Energy Harbor Nuclear Corp.
Perry Nuclear Power Plant
10 Center Road
P.O. Box 97
Perry, Ohio 44081

May 18, 2021
L-21-123

Subject:
Perry Nuclear Power Plant
Docket No. 50-440, License No. NPF-58
Response to Request for Additional Information regarding a License Amendment
Request that revises the Perry Nuclear Power Plant Emergency Plan
(EPID No. L-2020-LLA-0282)

FIGURE 5-2 - OSC AUGMENTED RESPONSE ORGANIZATION

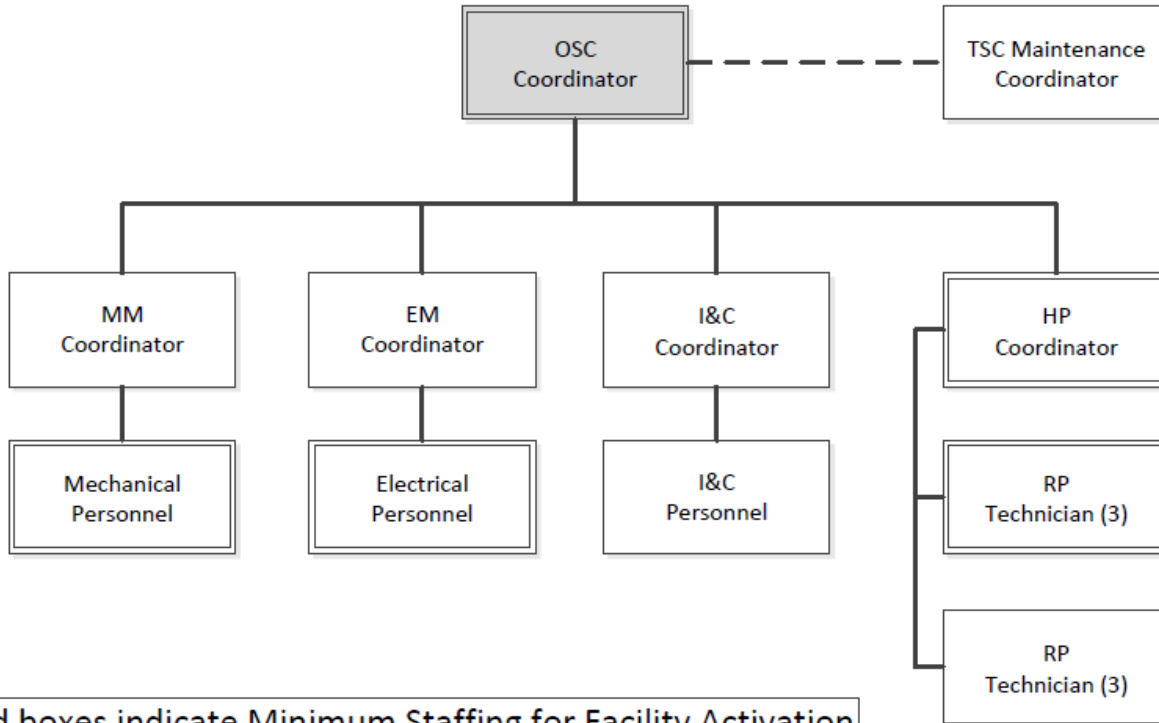
- **As proposed, it does not appear to the staff that the minimum staffing as described will allow the facilities to perform their intended functions (e.g., the minimum activation staffing for the Operations Support Center is one person, the OSC Coordinator). Please provide justification that the minimum facility staffing of each facility can implement the PNPP Emergency Plan until fully staffed.**

- **Describe how the functions related to repair and corrective actions will be adequately performed by the mechanical maintenance coordinator (OSC), electrical maintenance coordinator (OSC), and OSC coordinator (OSC) until relieved. Are these positions filled by personnel who maintain the same qualifications, training, and proficiency as the mechanical personnel (OSC) and electrical personnel (OSC)? Additionally, please clarify and/or correct the above statement concerning the role of the Mechanical Maintenance Coordinator Supervisor.**

The proposed changes to the PNPP Emergency Plan have been revised to reflect mechanical and electrical maintenance craft personnel arriving within 60 minutes of an Alert or higher classification to perform the initial troubleshooting and corrective actions work in the plant. In addition, the proposed changes to the PNPP Emergency Plan will reflect the mechanical maintenance coordinator and electrical maintenance coordinator positions in the OSC arriving within 90 minutes of an Alert or higher classification to provide supervisory oversight for their respective disciplines. The OSC coordinator position will direct repair and assessment personnel until the respective discipline supervisors arrive. These changes are incorporated in the clean pages of the proposed plan provided in attachments 2 and 3.

- Shaded boxes indicate Minimum Staffing for Facility Activation
- Double lined boxes indicate 60 minute responders
- Single lined boxes indicate 90 minute responders
- Dotted lines indicate positions in other facilities
